SUBDIVISION AUTHORITY MINUTES MEETING NO. 27

File NO. LDA14-0580

RE: Tentative plan of subdivision to create three (3) multiple family lots (MFL) and one (1) commercial lot, from the SE 13-51-25-W4M located north of 41 Avenue SW and west of James Mowatt Trail SW; **DESROCHERS**

File NO. LDA15-0079

SUBDIVISION CONDITIONS OF APPROVAL MAP

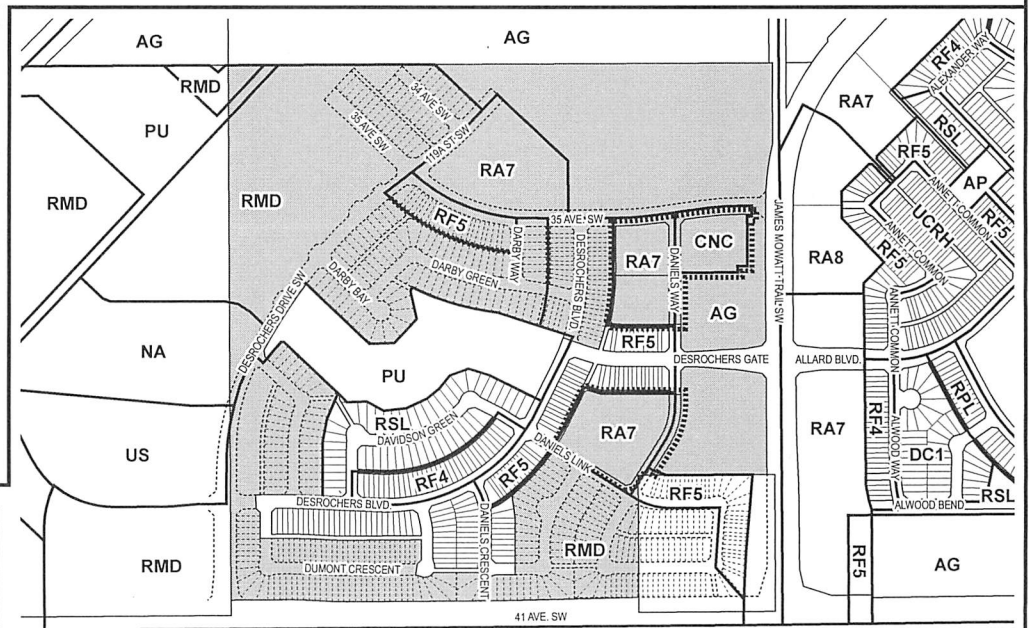
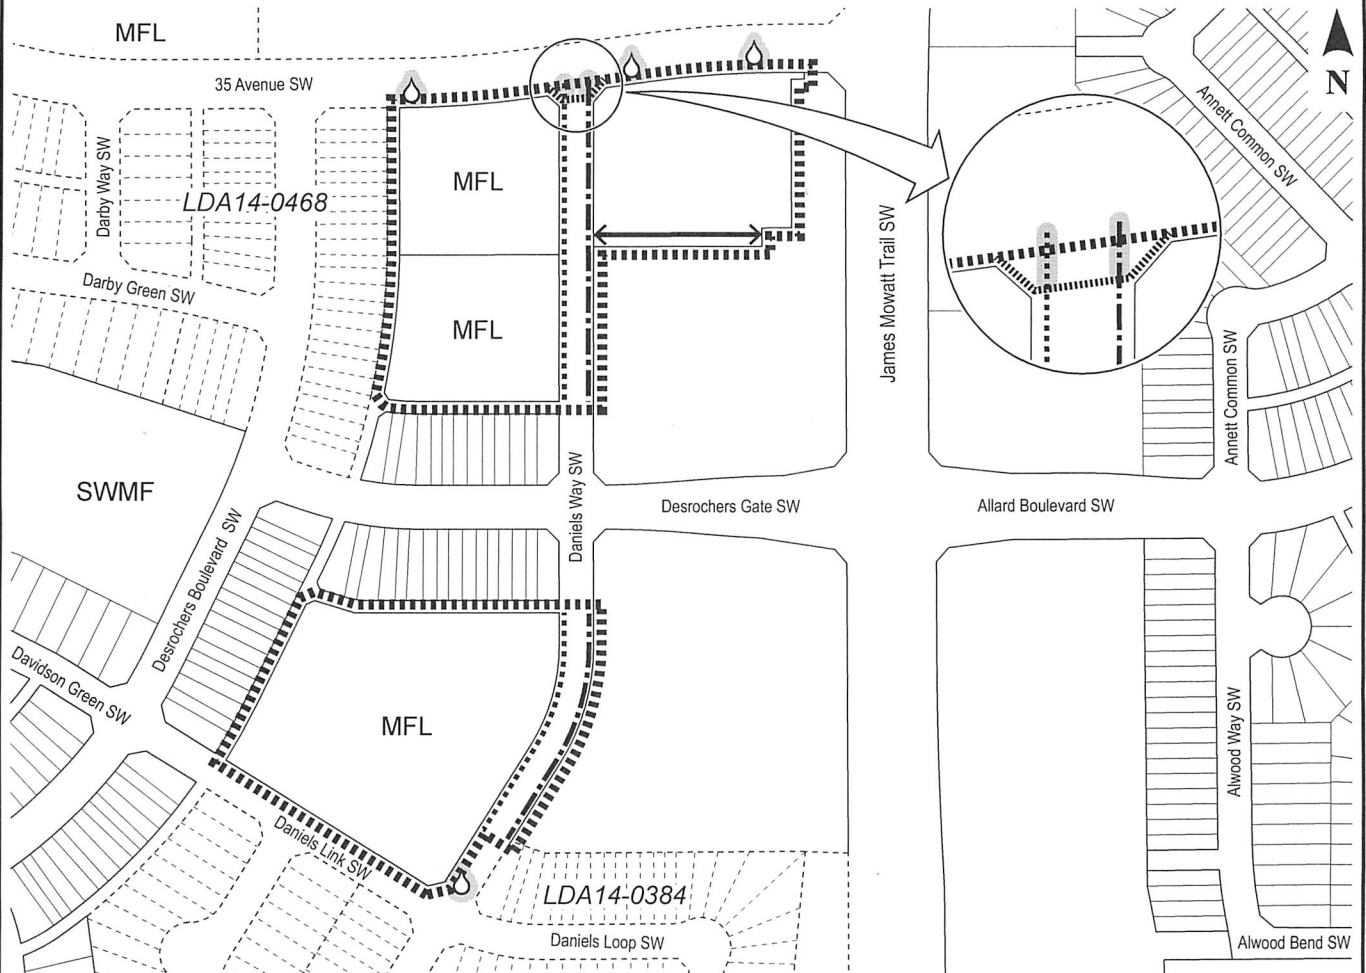
3. that the owner register an easement to allow maintenance vehicles access to the planned LRT power substation as shown on the "Conditions of Approval" map, Enclosure I;

4. that the subdivision boundary be amended to exclude the intersection of 35 Avenue SW and Daniels Way SW as shown on the "Conditions of Approval" map, Enclosure I;

7. that the engineering drawings include fire hydrants, to the satisfaction of EPCOR Water Services Inc., as shown on the "Conditions of Approval" map, Enclosure I;

8. that the engineering drawings include the extension of a 1.5 m and a 2 m concrete sidewalk, within the intersection of 35 Avenue SW and Daniels Way SW, to the satisfaction of Transportation Services and Sustainable Development, as shown on the "Conditions of Approval" map, Enclosure I;

9. that the owner construct a 1.5 m and a 2 m concrete sidewalk and provide boulevard trees, within Daniels Way SW, to the satisfaction of Transportation Services and Sustainable Development, as shown on the "Conditions of Approval" map, Enclosure I; and

SUBDIVISION CONDITIONS OF APPROVAL MAP

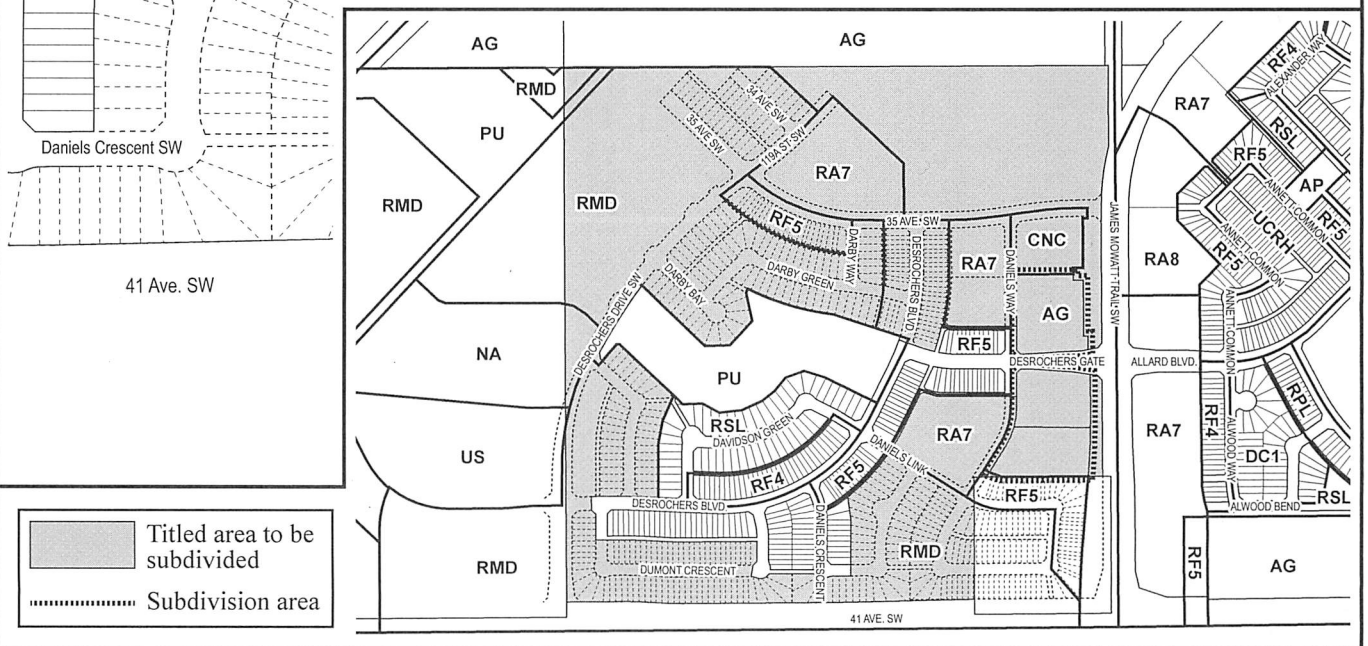
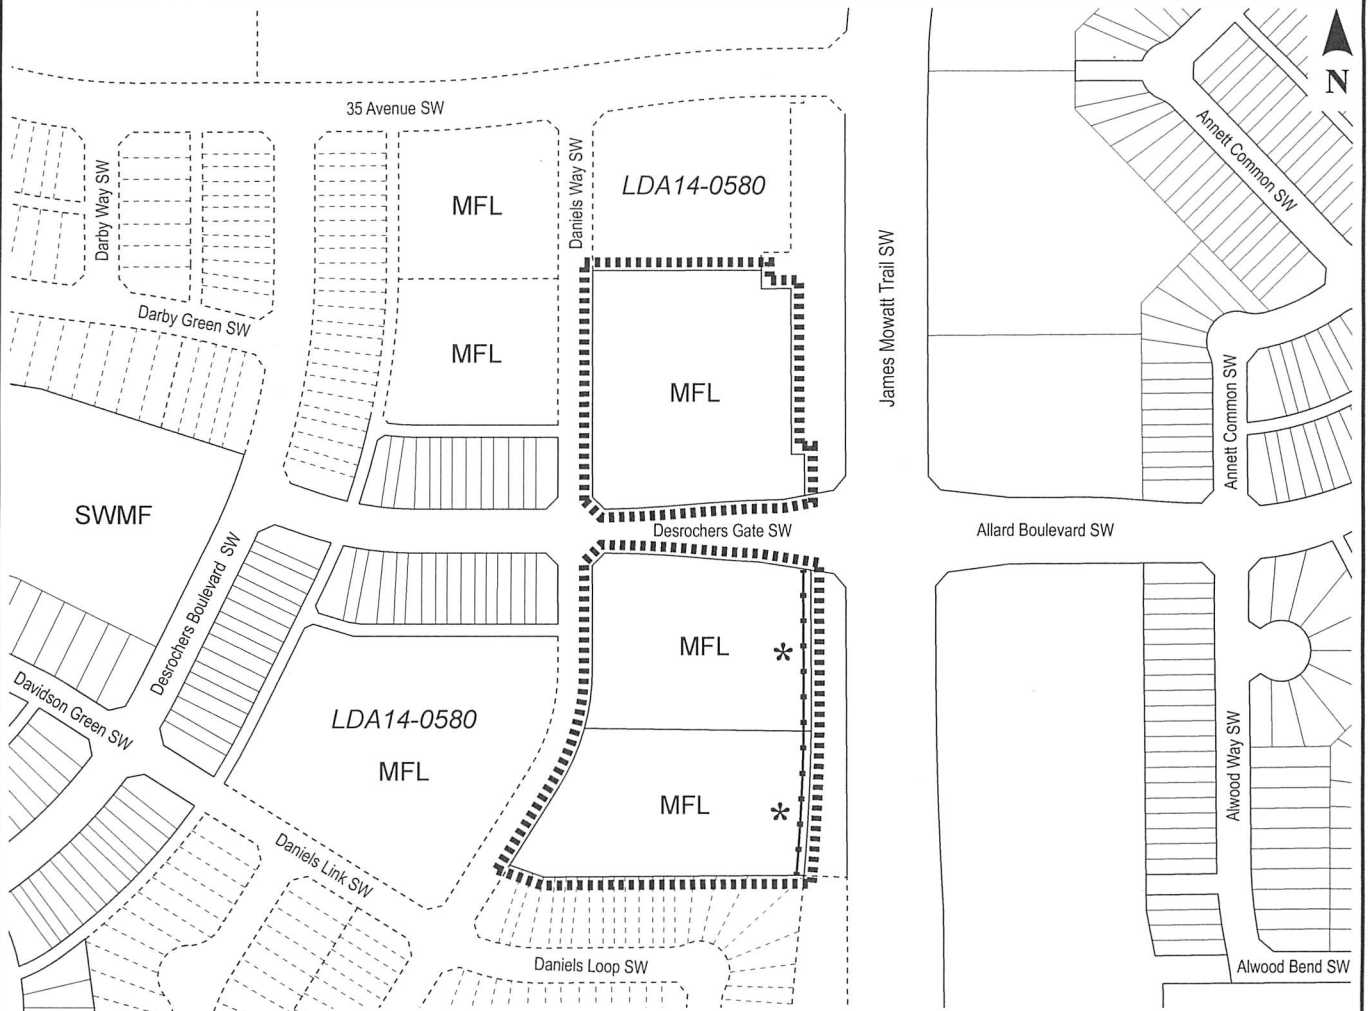
4. that LDA14-0500 to amend the Edmonton Zoning Bylaw shall be approved prior to the endorsement of this subdivision;
5. that the owner register a noise attenuation berm restrictive covenant in favour of the City of Edmonton against the lots backing onto James Mowatt Trail SW, to protect the integrity of the berm, as shown on the "Conditions of Approval" map, Enclosure I; and

7. that the owner construct a 1 m berm centered on property line and 1.8 m noise attenuation fence contained wholly within private property, as per the City of Edmonton Roadway Design Standards Drawing #5205, for all lots backing onto James Mowatt Trail SW, to the satisfaction of Transportation Services, as shown on the "Conditions of Approval" map, Enclosure I;

8. that the owner construct all fences wholly on privately-owned lands, to the satisfaction of Transportation Services and Sustainable Development, as shown on the "Conditions of Approval" map, Enclosure I; and
